**Re: ERO 025-0347 Request for an Amendment to Minister's Zoning Order,  
Ontario Regulation 10/24, City of Toronto**

# Toronto H1 Heliport Hospital Study

## Sick Kids Eastern Flight Path

Figure 1 - Inner Edge

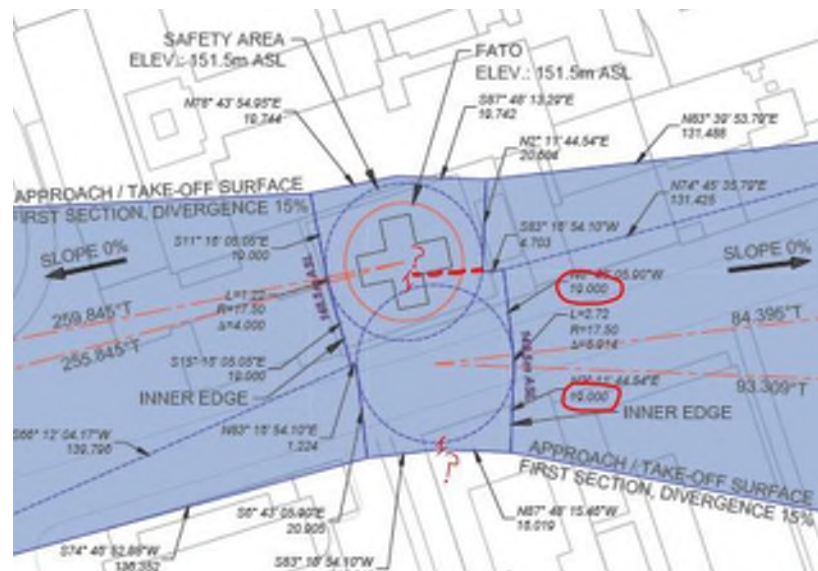
## 1. Inner Edge of Safety Area

The Inner Edge is not coincident with the Safety Area.

- a. Safety Area Width: 35m
- b. Inner Edge length from APP/T-O c/l:  $17.5\text{m} (35 \div 2)$ 
  - Drawing #SK3 appears to indicate an Inner Edge length of either 10 or 19m (unclear). Neither of which would be accurate. This dimension would be expected to be 17.5m

Figure 2 – Safety Area

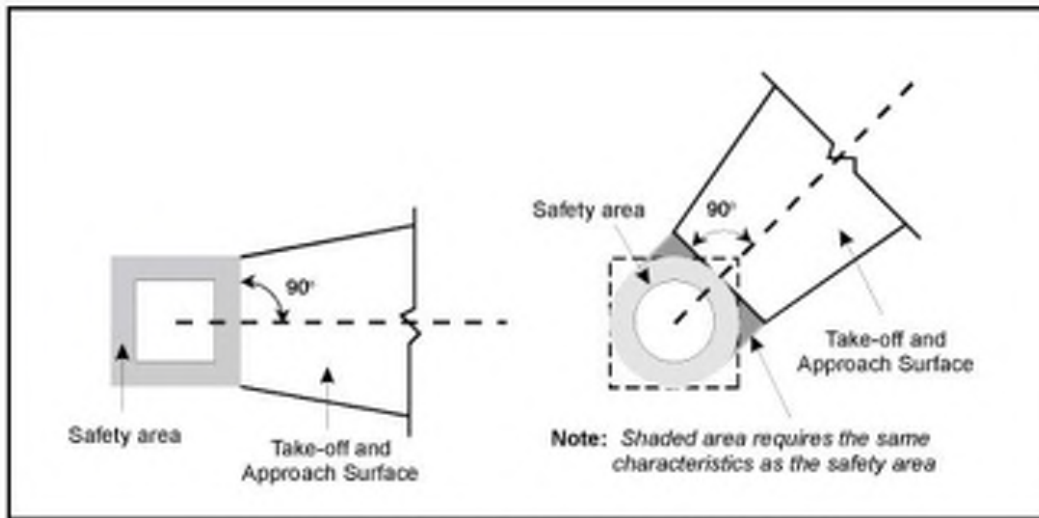
- Standard 325: section 325.29(1)(a)(i)(A) states that an inner edge of an approach surface (non-precision and precision) shall be perpendicular to the APP/T-O centreline and equal in length to the safety area.

- Having 2 designated centrelines is unusual. These centrelines (or lines) would normally represent the outer range of a flight path. Designating each line as a “flight path projected centreline” is an unfamiliar term. It would imply that the helicopter would fly only one of the 2 “centrelines” without veering off-course beyond an acceptable range.
- A flight path centreline in a typical APP/T-O surface would dissect these 2 lines in the middle with the outer lines becoming the outer boundaries of flight within which it would be assumed that the H1 performance calculations were assessed, and the helicopter could remain 4.5m above all obstacles within this flight path cone in the event of an engine failure.

**Figure 3 – MZO (2024) Critical Obstacles**

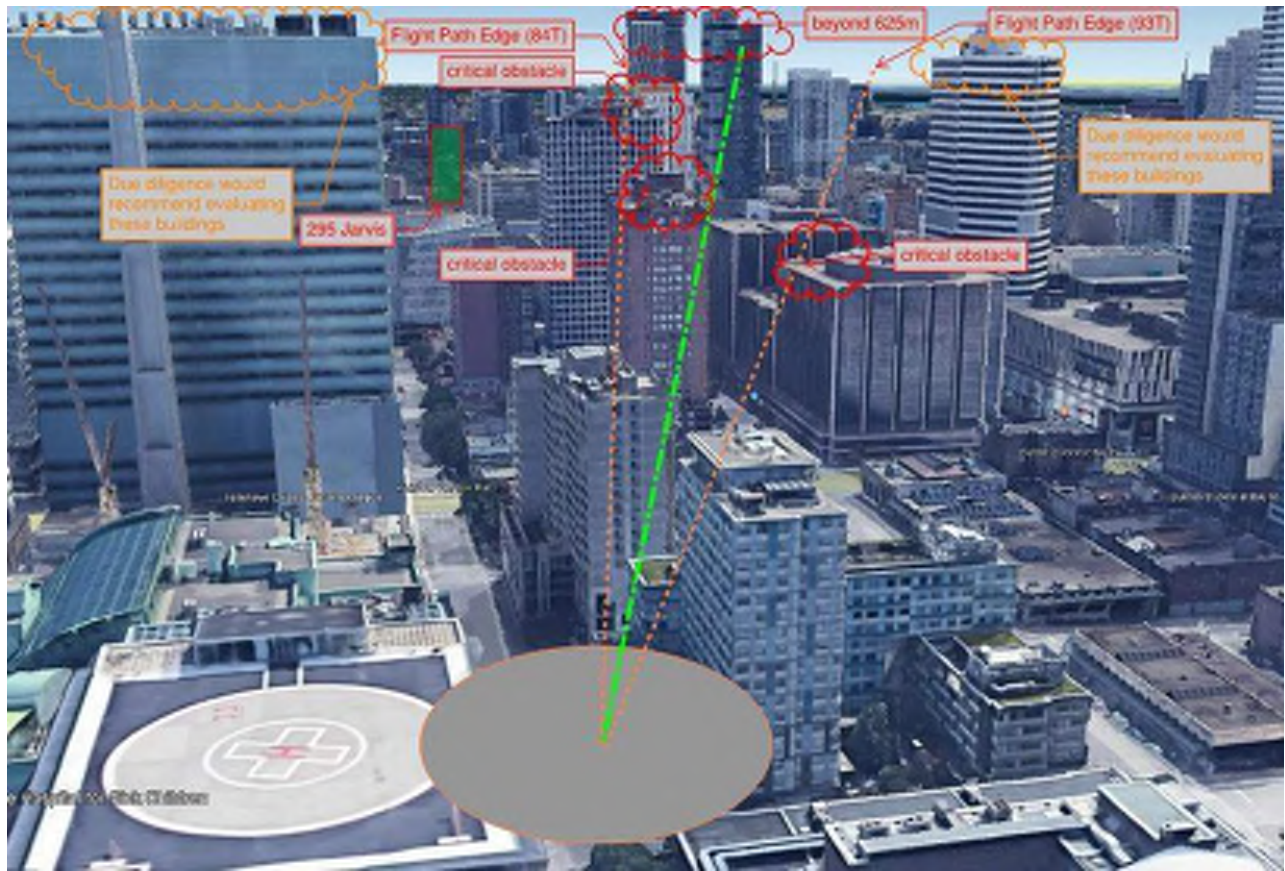
Confirmation is required with respect to which buildings/structures/objects were used to establish H1 APP/T-O Surface and if 4.5m was used as a clearance throughout the approach and departure profile as per Canadian Performance Class 1 (H1) operations. (These obstacles would have been included in the required survey that must be completed by the heliport operator for any H1 heliport.)

The following drawing is a sketch using Google Earth to demonstrate the proposed MZO (2024) helicopter flight path with known obstacles highlighted. The 84 and 93 degrees True bearings were used as the approximate edges of the flight path. Within this flight path are shown critical obstacles (buildings) that would be used to calculate the helicopter performance gradients with OEI and maintaining 4.5m above any and all of these obstacles. We have indicated that as part of the due diligence aspect of the evaluation, the high buildings just outside the edges of the flight path would also be included in the helicopter performance evaluation given the proximity of these buildings to the proposed flight path.

Figure 6 – MZO (2024) Sections

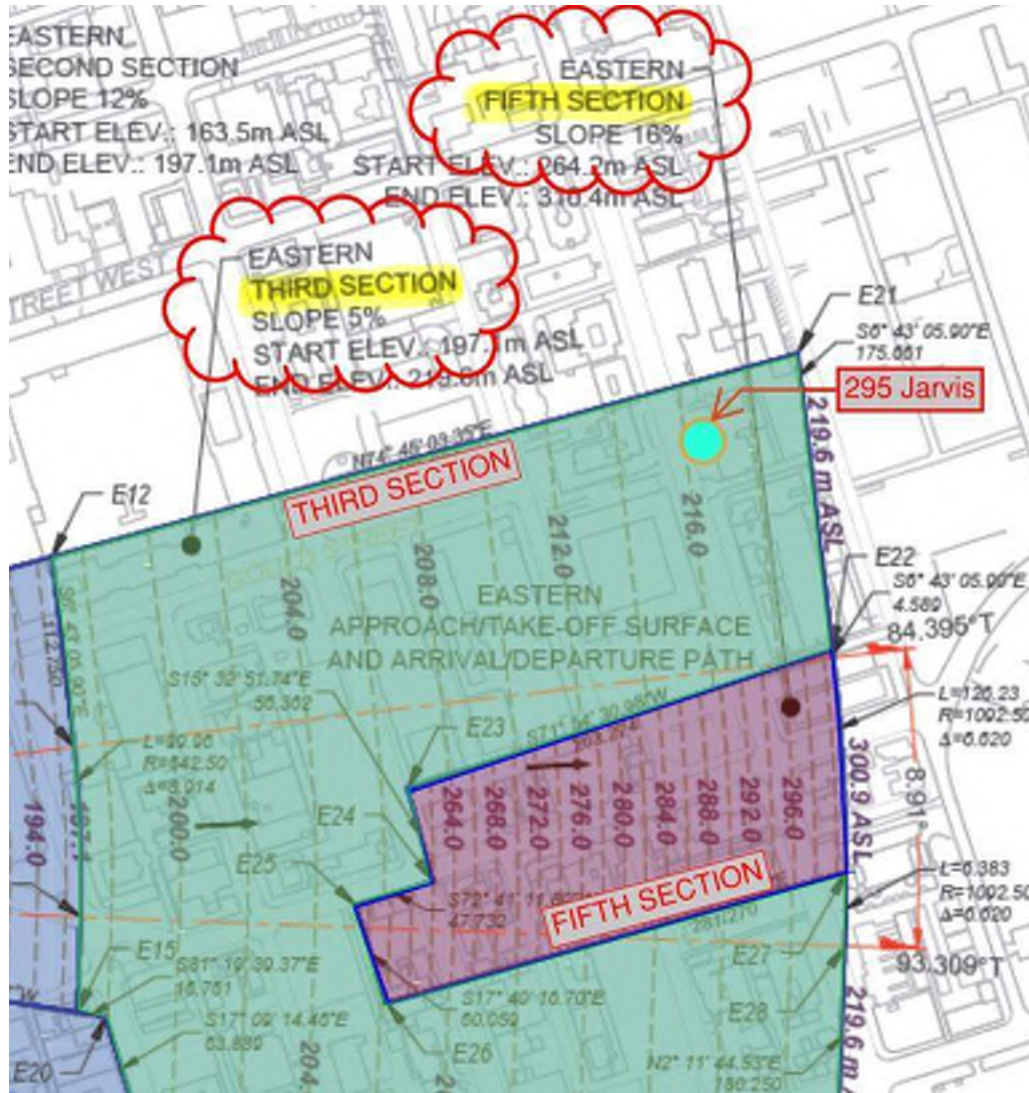
### 3. Prescribed H1 Approach/Take-Off (OLS) Slopes

The Eastern Third Section of the Sick kids MZO (2024) OLS is listed with a 5% slope. This is a very shallow slope when considering that much less powerful helicopters (H2/H3) are required to climb out at a 16% slope (see Standard 325, Table 4-1). The fact that much higher buildings are in closer proximity to the heliport leads to the following 2 inferences:

- Higher buildings close to the heliport would result in the helicopter flying a much steeper trajectory on departure, therefore leaving one to wonder why the shallow departure surface at the greater distance from the heliport.

- b. The middle of the third section is occupied by the Fifth section containing higher buildings and a higher app/dep slope of 16%. The Fifth section is within the 2 edges of the flight path (noted on MZO drawing as “Flight Path Projected Centreline”) and therefore is subject to the High Performance H1 evaluation criteria. Having the areas immediately surrounding the Fifth Section drop down to a 5% slope seems a bit counter intuitive. A 16% slope is generally considered to be optimal in terms of H1 helicopter performance levels and obstacle clearance requirements.

An understanding of the reasoning behind the use of this shallow slope is critical to the development of any potential alternatives that may provide less restrictive urban development parameters.

**Title:** HOSPITAL FOR SICK CHILDREN HELIPORT  
ENHANCED FLIGHT PATH PROTECTIONS  
WITH METES AND BOUNDS

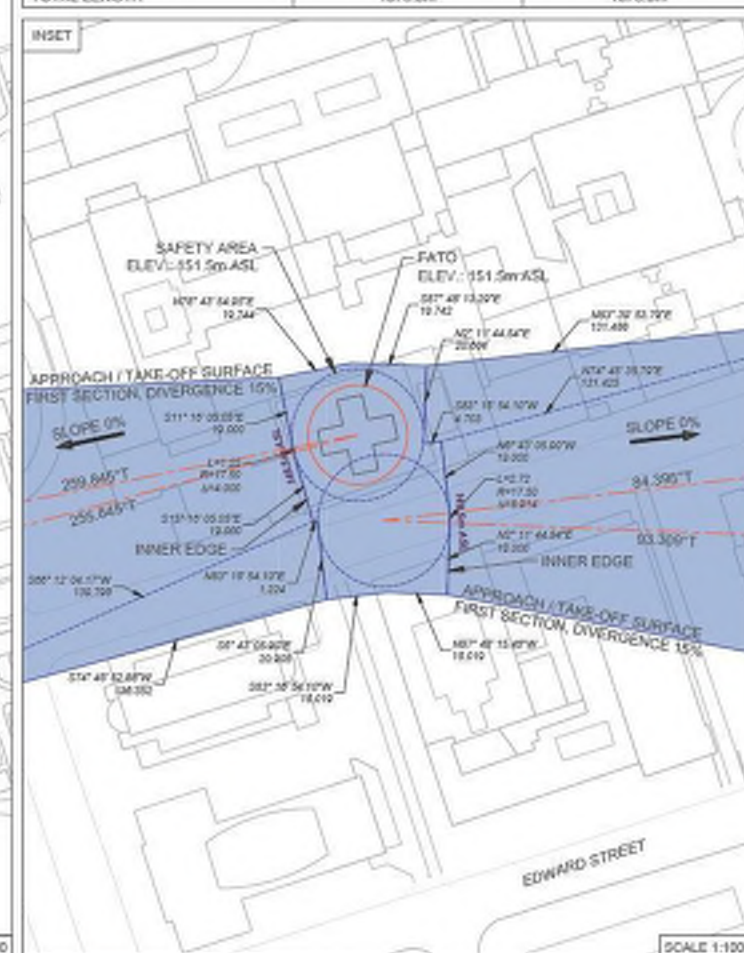
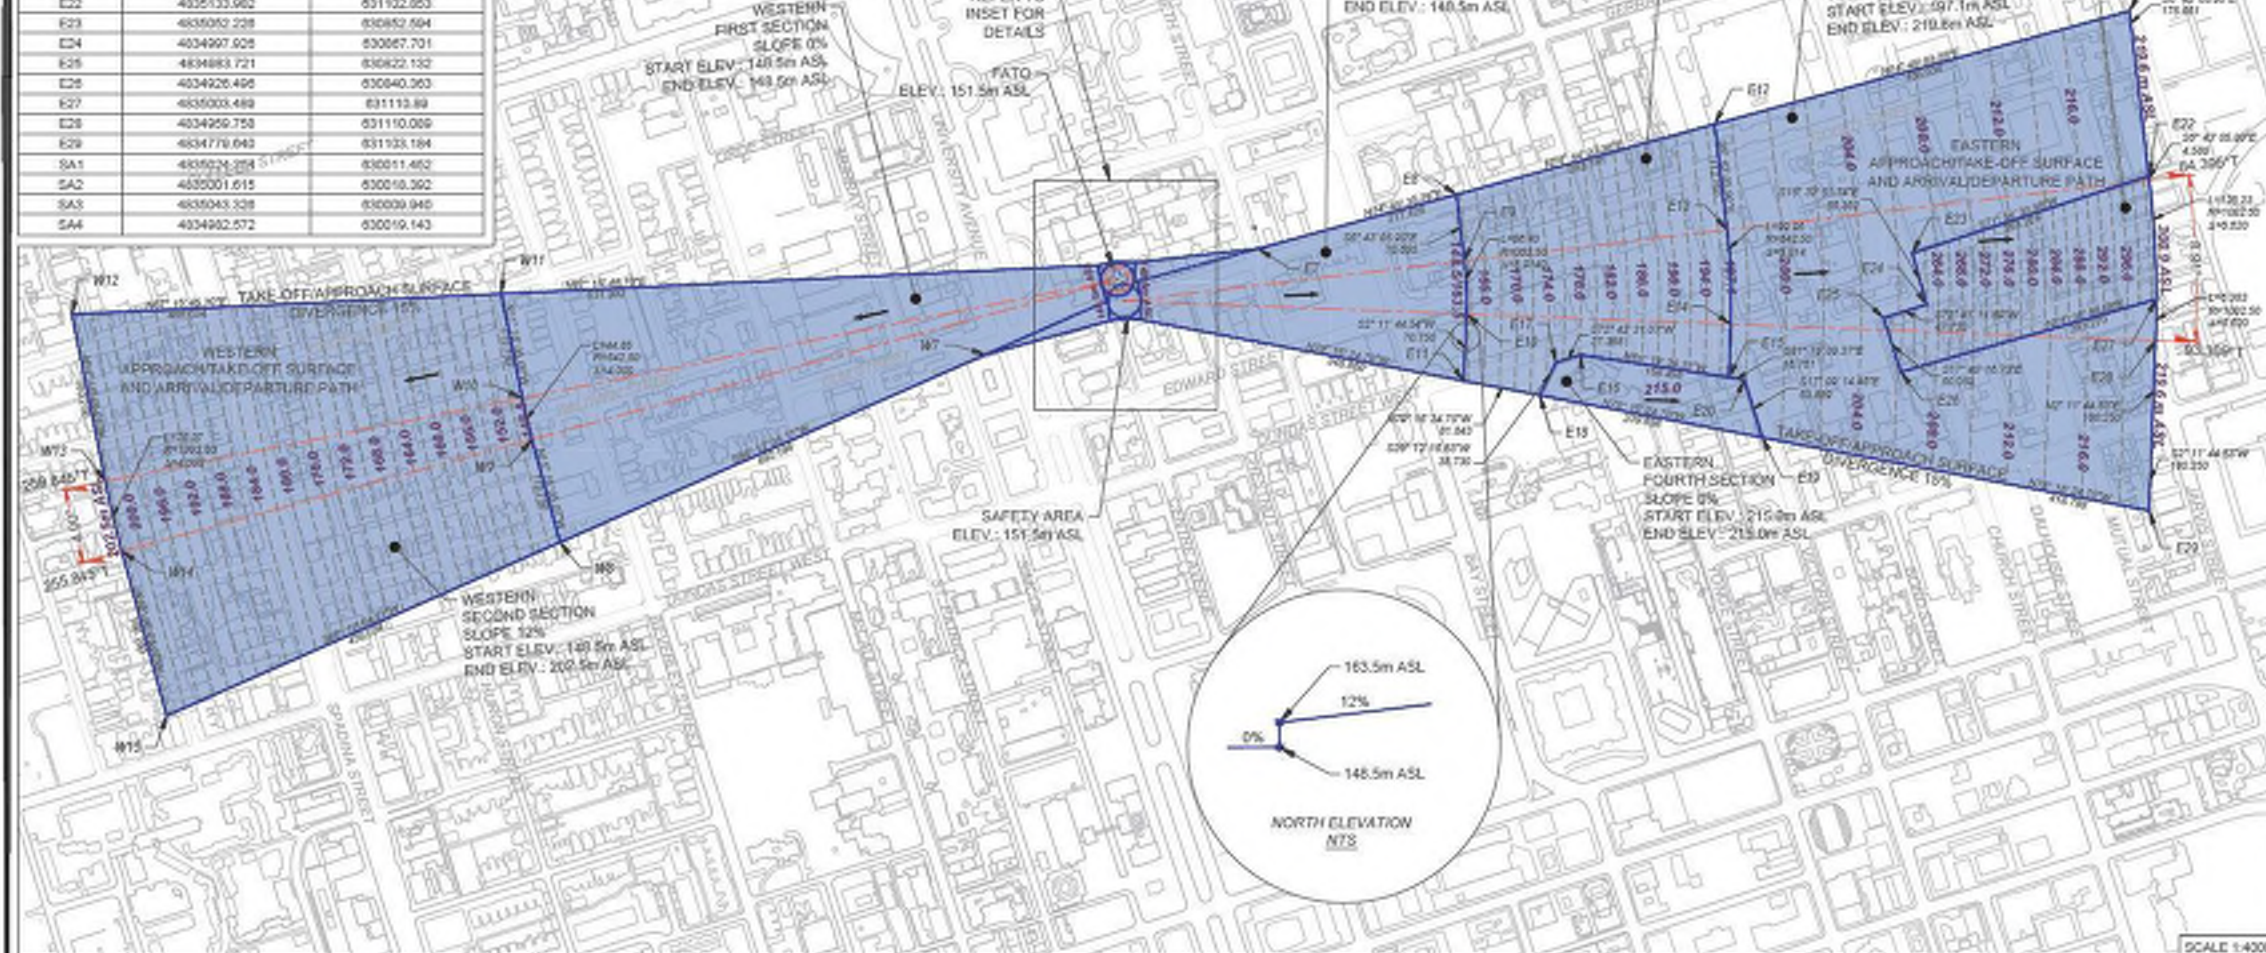
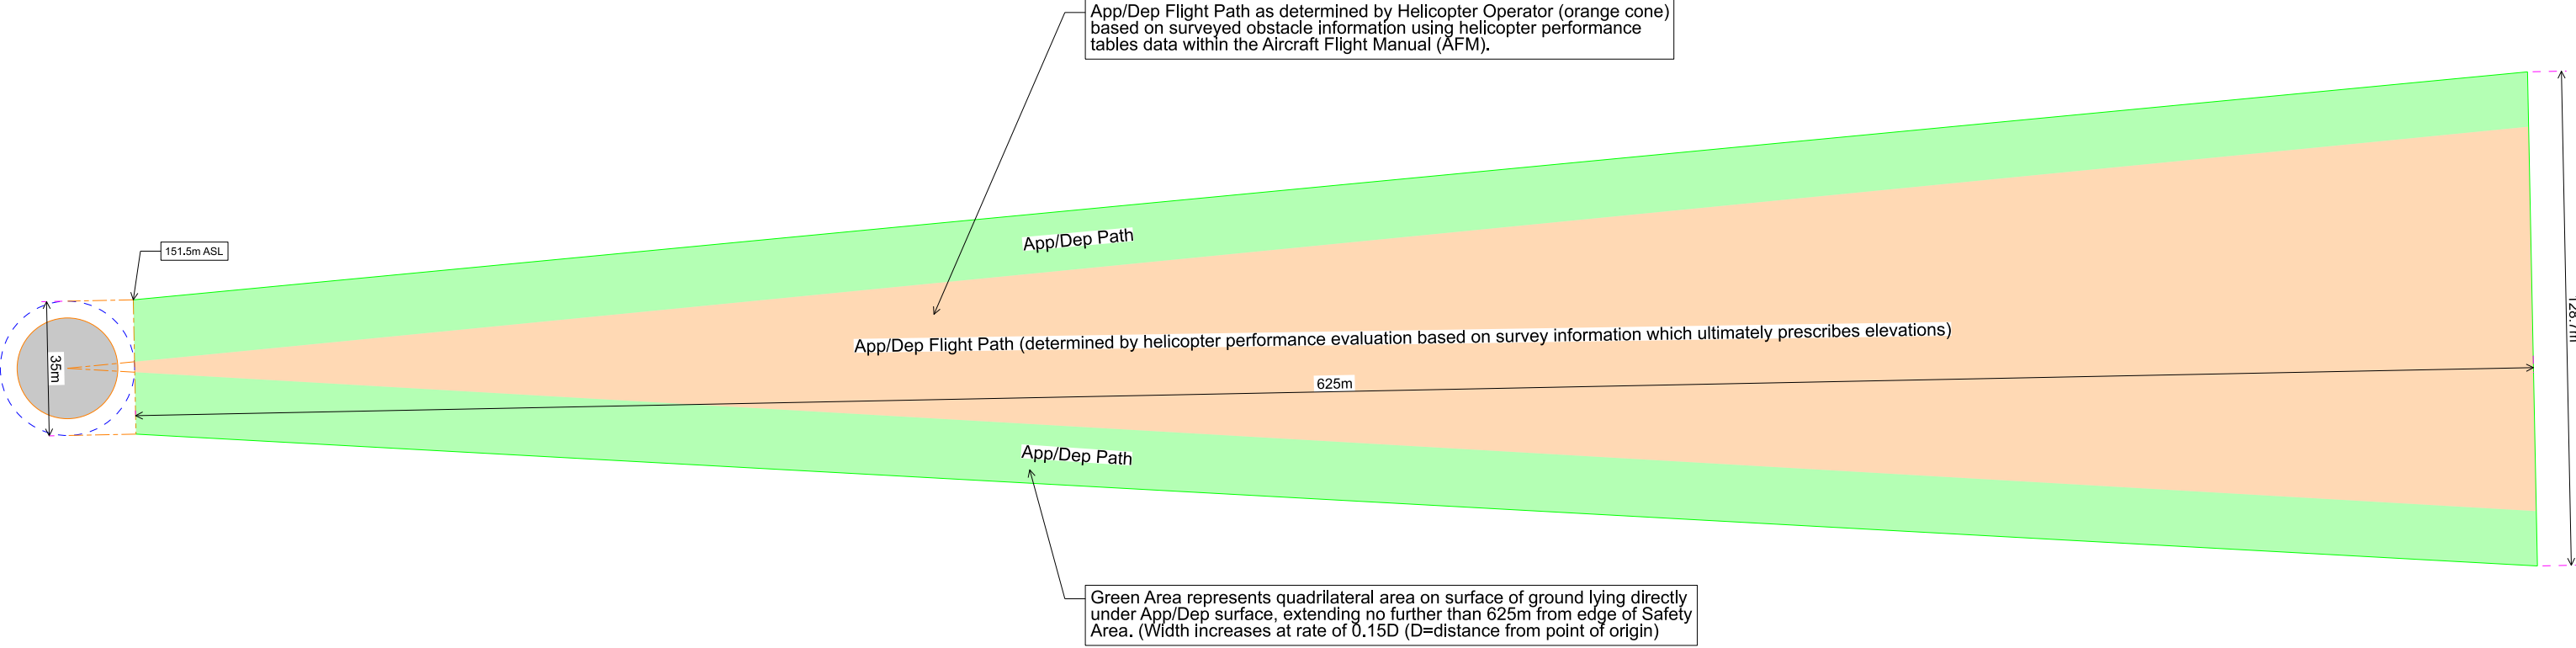
This study reviews the recent MZO Flight Path modifications for Hospital for Sick Children Heliport Enhanced Flight Path Protections With Metes and Bounds, Oct 31, 2024 (see Appendix B) and has been conducted with respect to understanding the methodology used to establish the Obstacle Limitation Surfaces (OLS) or, in more common terms, the Flight Path Protection area.
